Re: Garrett Pit, Mine ID# M-1978-271
Field Inspection, May 15, 2017

MINERALS PROGRAM INSPECTION REPORT**PHONE: (303) 866-3567**

MINE NAME: Garrett Pit	MINE/PROSPECTING ID#: M-1978-271	MINERAL: Gravel	COUNTY: Conejos
INSPECTION TYPE: Monitoring	INSPECTOR(S): Dustin M. Czaplá	INSP. DATE: May 15, 2017	INSP. TIME: 13:00
OPERATOR: Asphalt Gravel Products, Inc.	OPERATOR REPRESENTATIVE: Alonzo Salazar	TYPE OF OPERATION: 112c - Construction Regular Operation

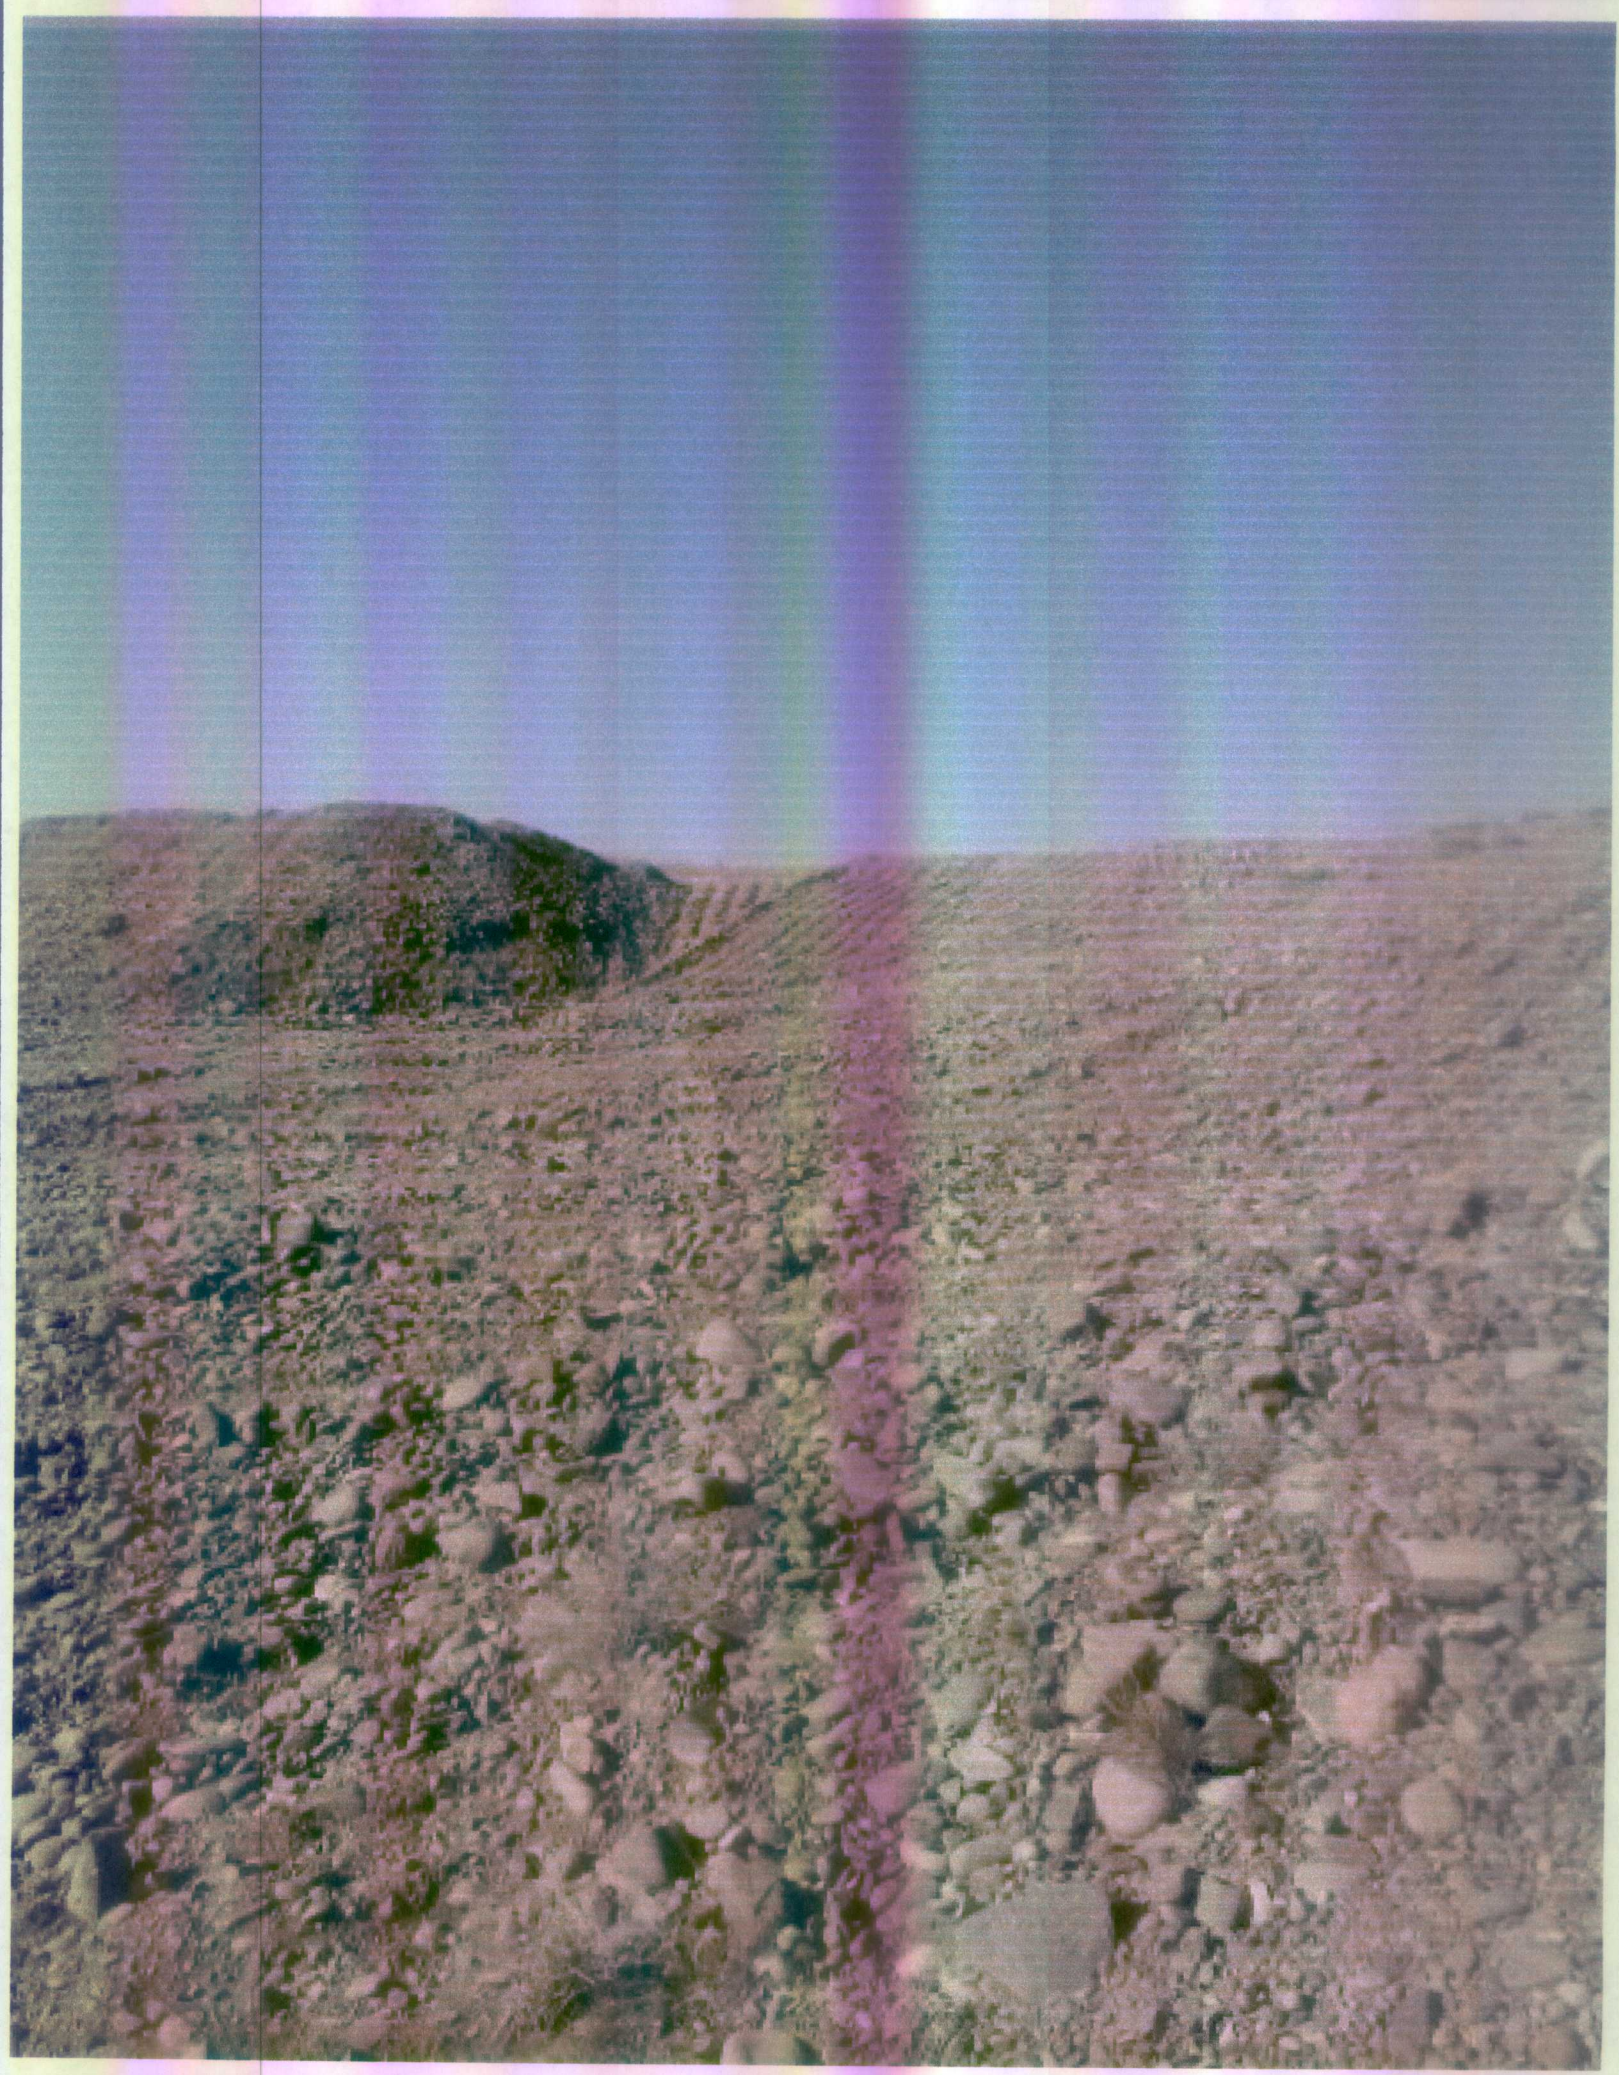
PROBLEM/POSSIBLE VIOLATION: Problem: Improper storage and containment of fuels and/or other hazardous materials was present on site. An unmarked drum containing hydrocarbon has leaked into the soil.

CORRECTIVE ACTIONS: Remove barrel and properly dispose of contaminated soil. Submit photo documentation to the Division to show that this has been done by the corrective action due date.

PROBLEM/POSSIBLE VIOLATION: Problem: An erosion gully was observed on the east side of the pit. The gully is head-cutting toward the permit boundary. This is a problem at this time for failure to protect the affected land from erosion.

CORRECTIVE ACTIONS: Provide photo documentation to the Division verifying the erosion gully has been repaired, and that the site has been reconstructed and stabilized to prevent erosion damage by the corrective action due date.

The following corrective actions have been completed with regard to the Inspection Topics for (1) Toxic Materials and (2) Erosion. We have removed the barrel and properly disposed of contaminated soil and also we have repaired the erosion gully and have reconstructed/stabilized the area(s) to prevent further erosion damage in the East and West Side of the pit. I am enclosing pictures of the areas involved to substantiate compliance with the corrective actions recommended by you Minerals Program Inspection Report dated 5/19/2017.
